INT REMODEL - RESTAURANT (NO REMODEL TO KITCHEN)

CHUCK E. CHEESE'S PIZZA. #558
5156 N. ACADEMY BLVD.
COLORADO SPRINGS, CO. 80918
C. E. C. ENTERTAINMENT, INC.
4441 WEST AIRPORT FREEWAY
IRVING, TEXAS 75062

COLORADO SPRINGS FIRE PREVENTION
PLAN REVIEW REPORT

Tax Id:	DSN:		
Project Description: Remodel of existing Chucke Cheeses Restaurant - 5158 N Academy - fire sprinkled A 2.1 assembly occupancy			
Business Name: CHUCKE CHEESES - A2.1		Address: 05156 N. ACADEMY BL.	
Plan Id: 20010347-CN-1		Plan Description: REMODEL	
Plan Status: Approved/Corrected		Contractor:	
Review Status: APP/CORRECTED	Plan Reviewer: CHAMBERS, STEPHEN M.		Review Date: 5/14/2001
Status Approved	Comment They have provided a site plan with adequate addresses, the plans are now approved as corrected.

PLOT PLAN

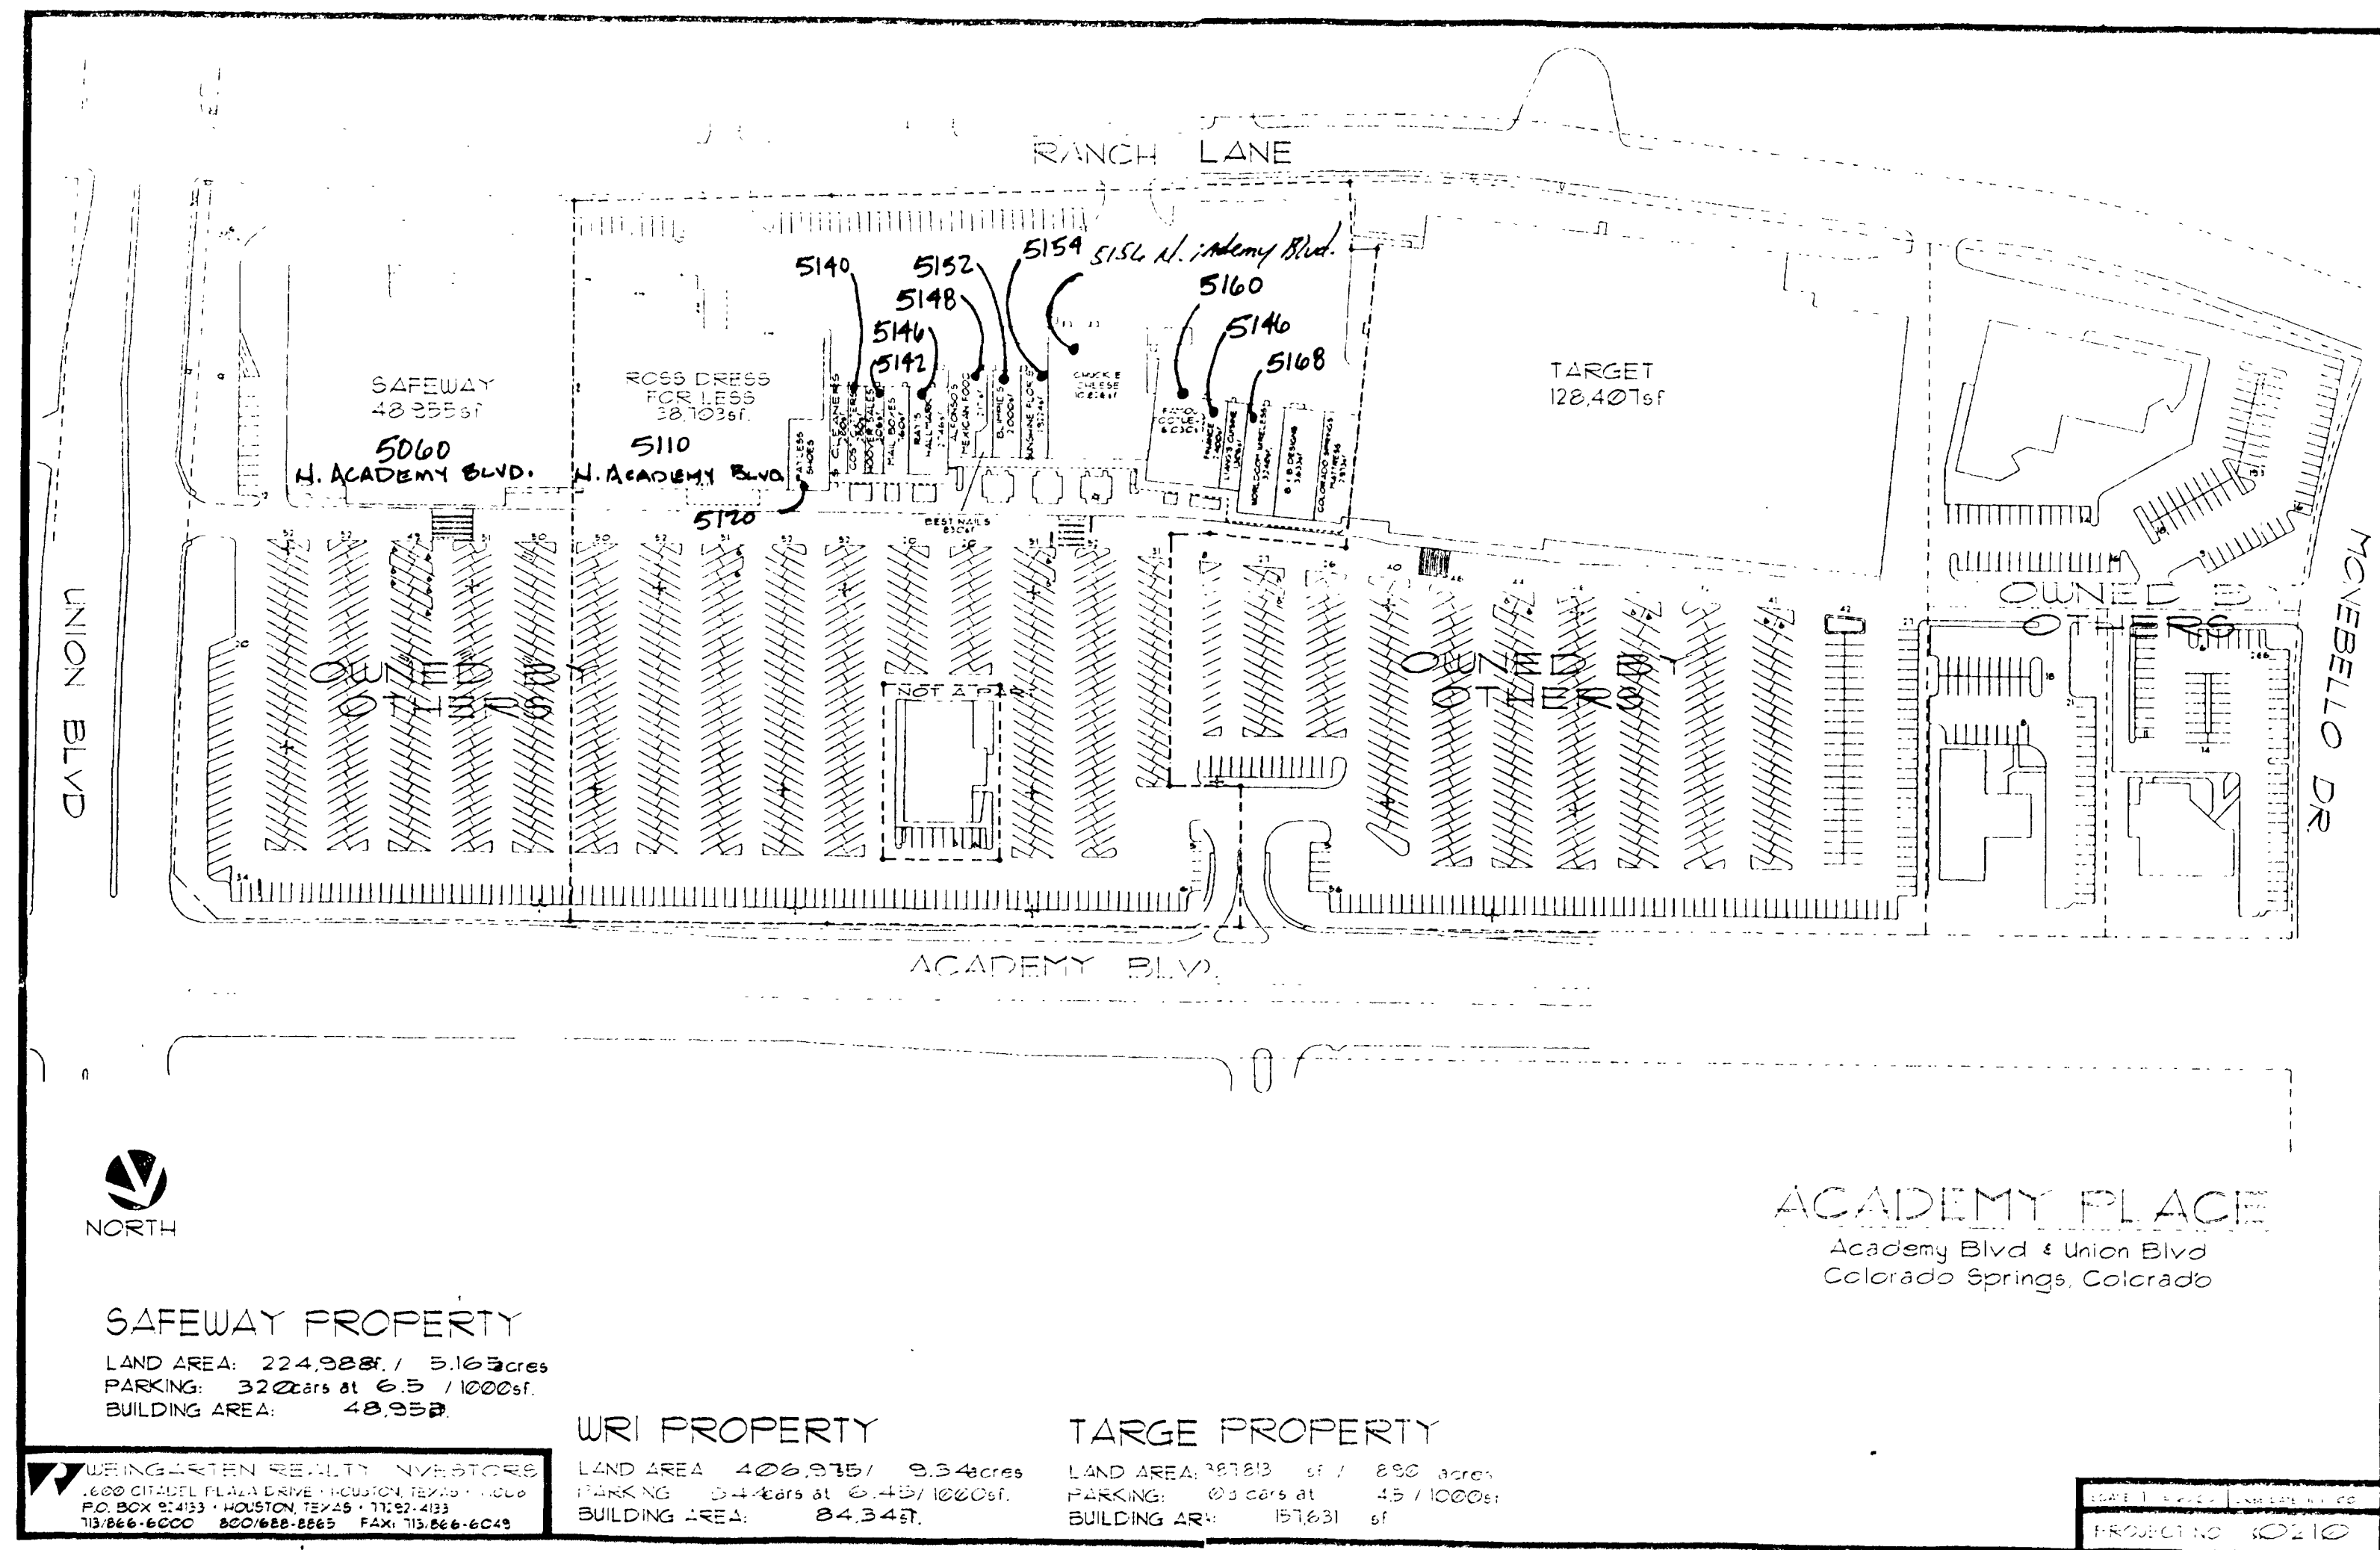
Disapproved Please, due to the numbers of plans we must review daily, do not call to check on the status of your plans. Once construction plans have been reviewed by the CSFD, the plans are returned to The Pikes Peak Regional Building Department. You may check their web site @ www.pprbd.org for plan all review statuses. smc 12/00
Beginning March 1st, 2001, ALL CONSTRUCTION PLAN SUBMITTALS are required to have a plot plan indicating the street name(s) and address(es) for the structures and/or suites in proximity to the project. The drawings must also provide locations of proposed and existing structures.

ADDRESS-FOR-BUILDING. Provide a minimum of 5" high building address numbers placed on the structure in a highly visible location facing the addressed street. If the building is over 100 feet from the addressed street, an additional address number must be posted at the addressed street entrance to the building. Additional address numbers may also need to be provided on some sites, as deemed necessary by the CSFD Inspection Division. smc 12/00

01 LIGHTING & ELECTRICAL PLAN
SCALE: 1/8" = 1'-0"

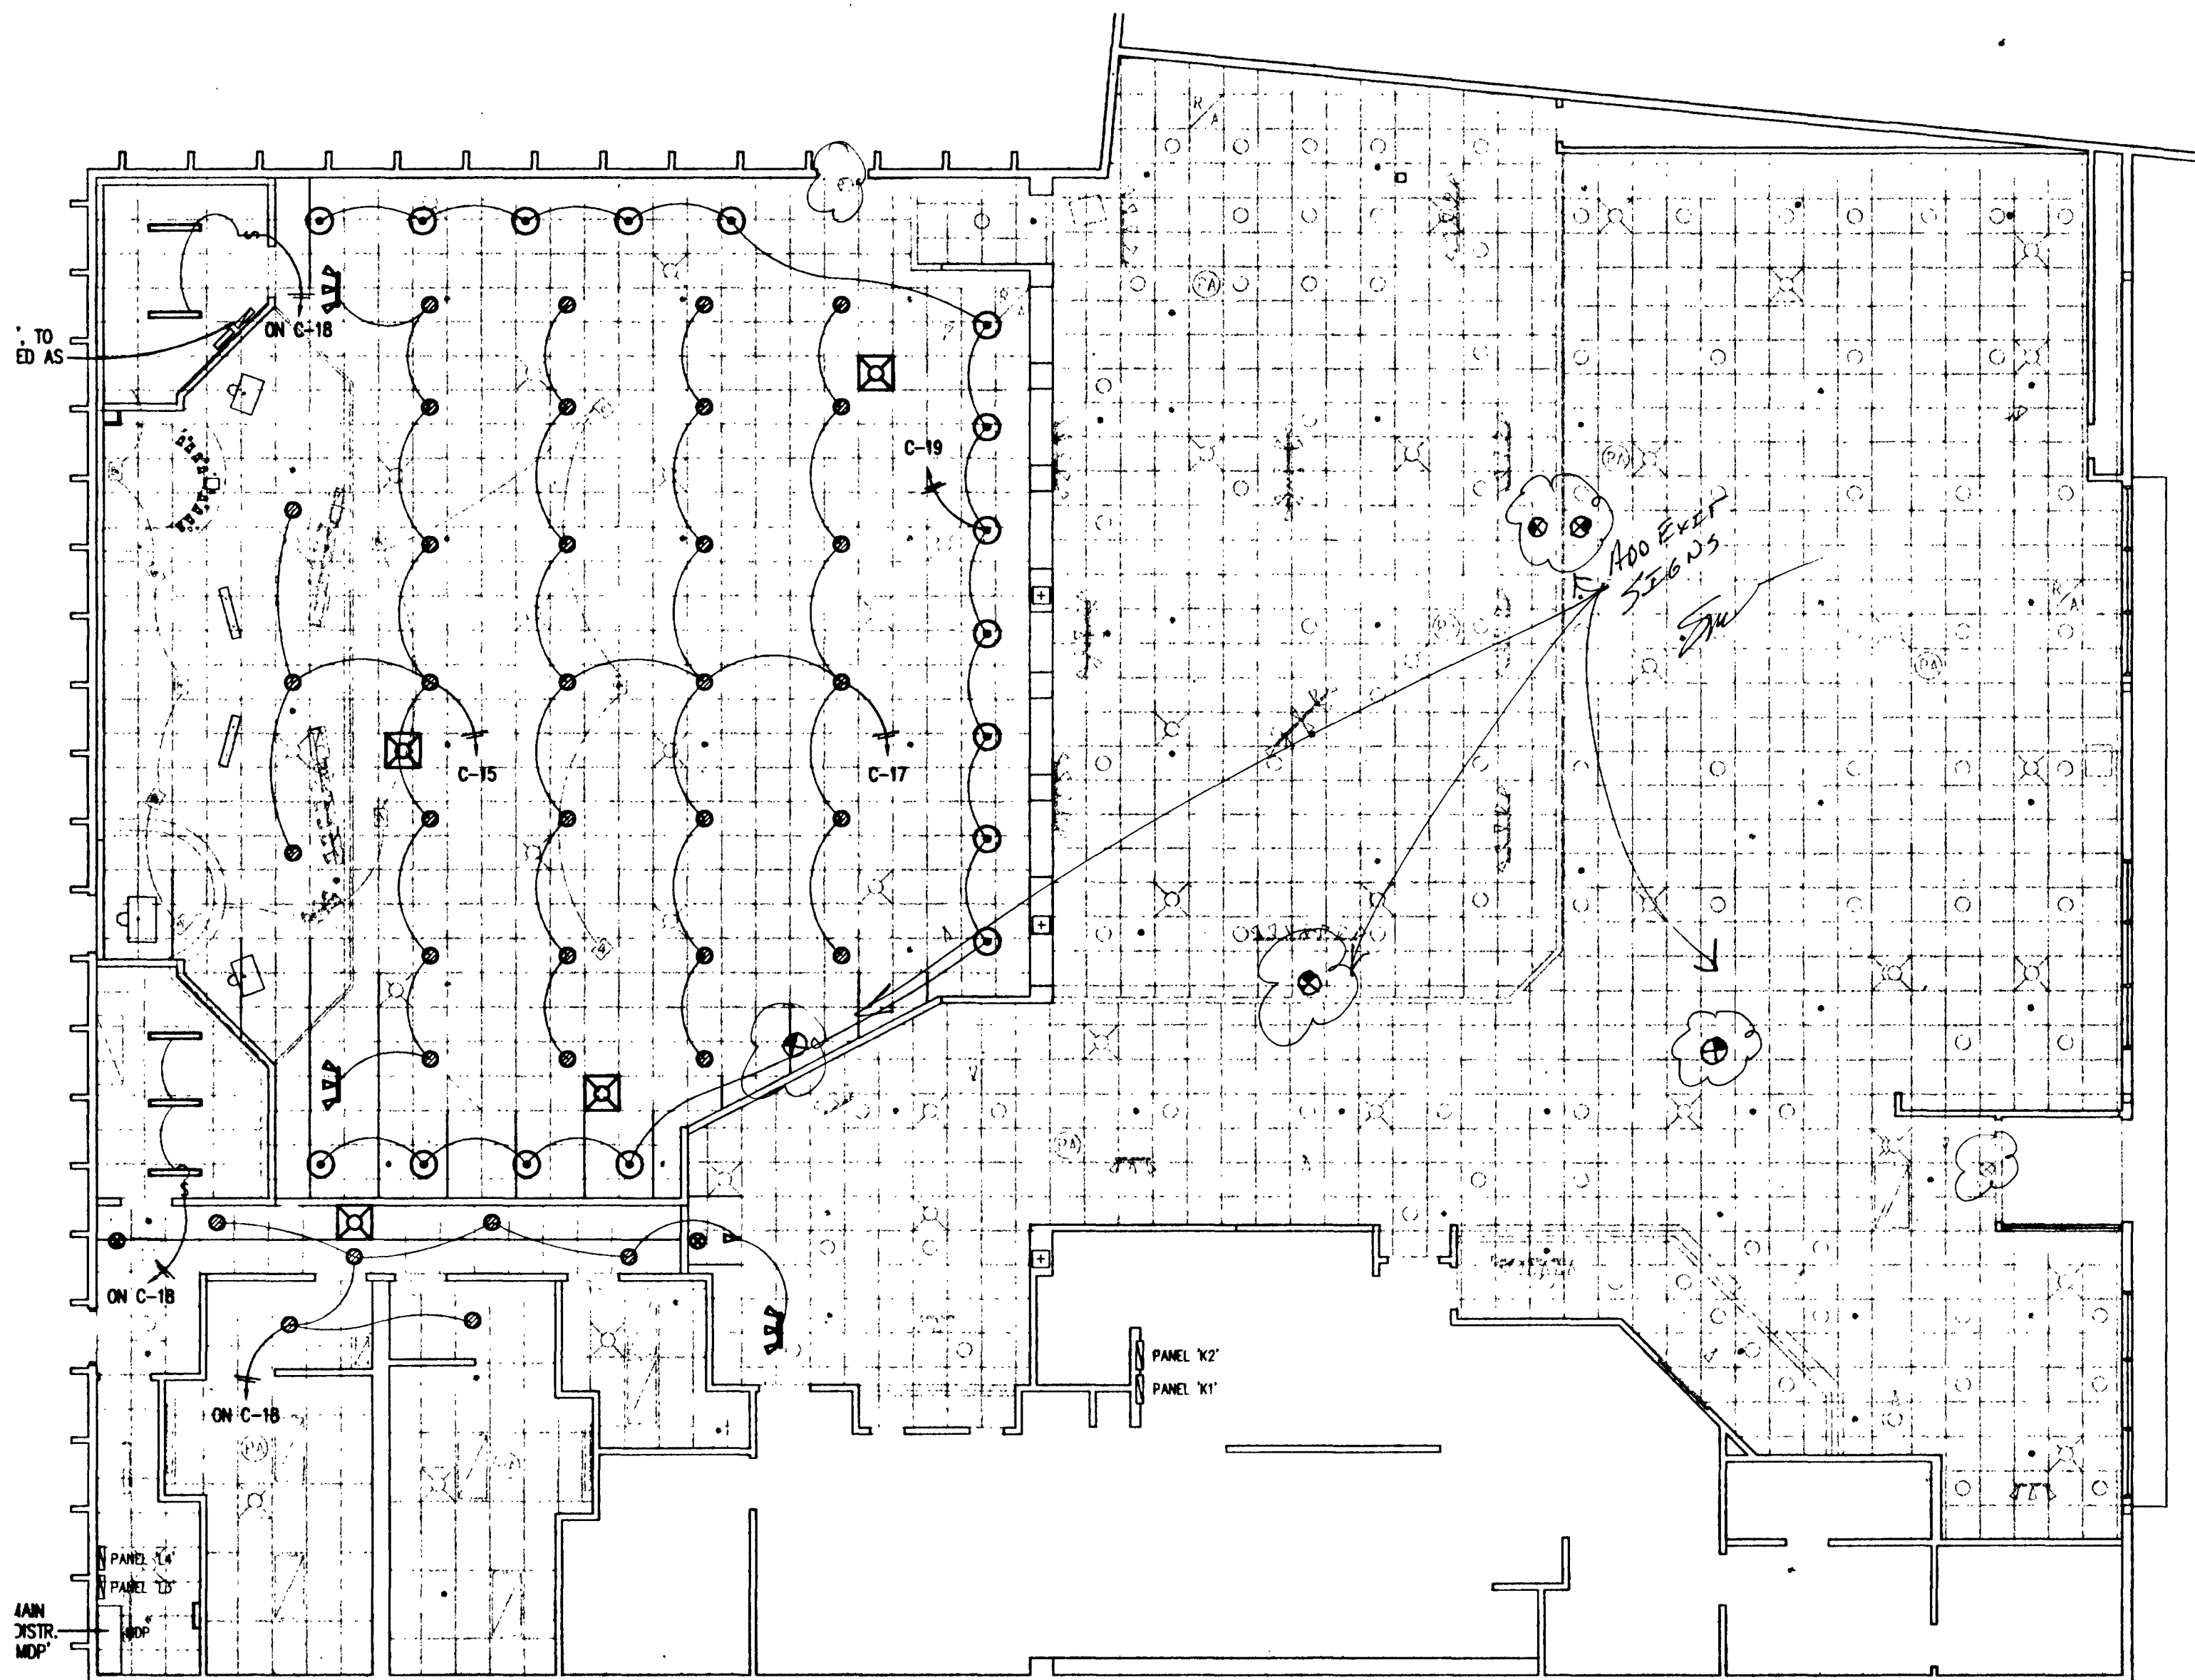
FYI
Provide adequate exit signage, night lighting, and emergency lighting units, as required by code. See page __E1__ of plans for additional units required.

Show the E.M. lighting within the facility

- A. ALL ELECTRICAL WORK SHALL BE IN ACCORDANCE WITH THE CURRENT NATIONAL ELECTRICAL CODE AND THE LOCAL REGULATIONS.
- B. BRANCH ELECTRICAL CIRCUITS SHALL NOT HAVE A VOLTAGE DROP EXCEEDING 3%.
- C. SPECIAL ELECTRICAL NOTE:
- THE REFLECTED CEILING PLAN DEPICTS REVISED FIXTURE LOCATIONS.
SEVERAL FIXTURES WERE SLIGHTLY RELOCATED FROM THEIR EXISTING LOCATIONS (RECORDED DURING A VISUAL SURVEY) TO ACCOMMODATE THE NEW LIGHTING PLAN.
AS BUILT ELECTRICAL DRAWINGS OF PREVIOUS REMODELING EVENTS WERE REVIEWED AND DO NOT APPEAR TO LOCATE EACH CIRCUIT SUPPORTING EXISTING LIGHTING FIXTURES AND APPLIANCE OUTLETS. THE CONTRACTOR SHALL REWIRE THESE RELOCATED FIXTURES AND CIRCUIT TO PANEL 'C'.
PANEL 'C' REPLACES PANEL 'LC'.

SHOW E.M.
LIGHTING
S.W.
